| Well Name: SILVER BAR 35 FED STATE COM | Well Location: T19S / R29E / SEC 35 / SWSW / 32.6125698 / -104.0539456 | County or Parish/State: EDDY / NM |
| Well Number: 134H | Type of Well: OIL WELL | Allottee or Tribe Name: |

Type of Action: APD Change

*Changes approved through engineering via **Sundry 2819947** on 12/16/2024. Any previous COAs not addressed within the updated COAs still apply.*

ACREAGE DEDICATION PLATS

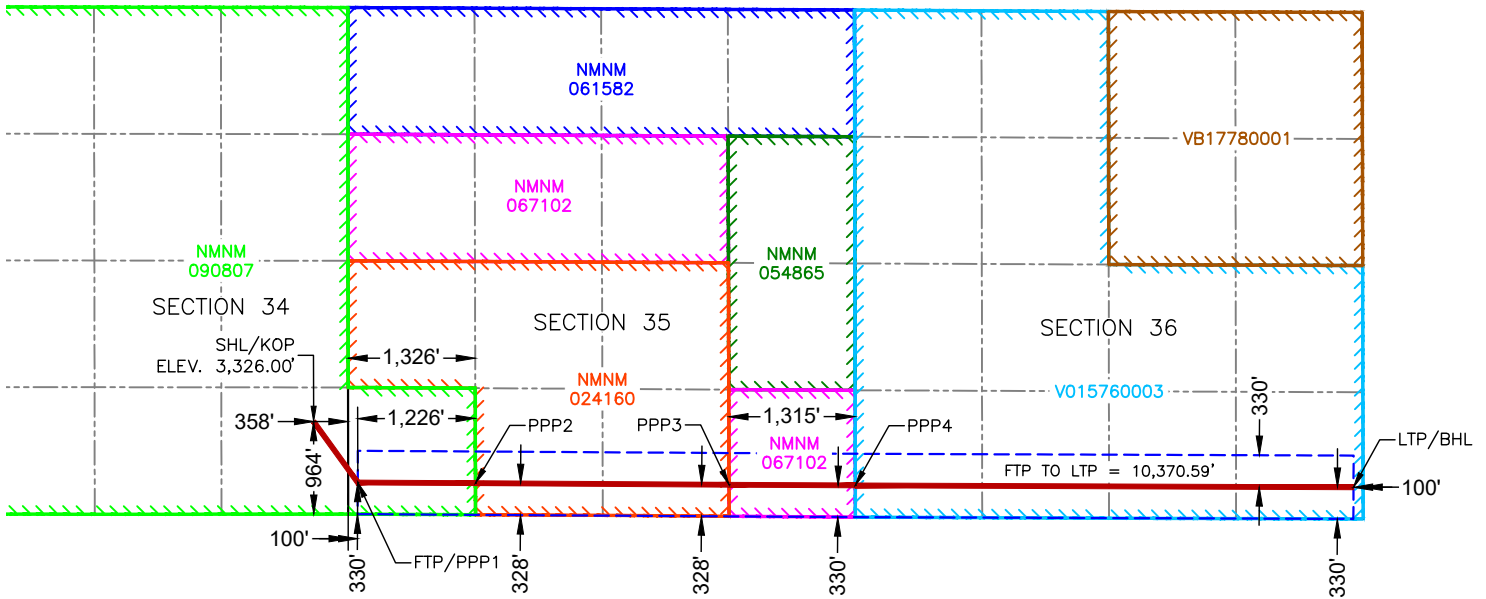
Surface Location: Revised

Change From: 970 FSL & 65 FWL, SWSW-Sec 35-19S-29E

Change To: 964 FSL & 358 FEL, SESE-Sec 34-19S-29E

FTP: Revised

Change From: 410 FSL & 100 FWL, SWSW-Sec 35-19S-29E

Change To: 330 FSL & 100 FWL, SWSW -Sec 35-19S-29E

LTP: Revised

Change From: 410 FSL & 100 FEL, SESE-Sec 36-19S-29E

Change To: 330 FSL & 100 FEL, SESE -Sec 36-19S-29E

BHL: Revised

Change From: 410 FSL & 10 FEL, SESE-Sec 36-19S-29E

Change To: 330 FSL & 100 FEL, SESE -Sec 36-19S-29E

SURFACE HOLE LOCATION & KICK-OFF POINT
 964' FSL & 358' FEL
 ELEV. = 3,326.00'
 NAD 83 X = 626,939.36'
 NAD 83 Y = 586,692.44'
 NAD 83 LAT = 32.612561°
 NAD 83 LONG = -104.055324°
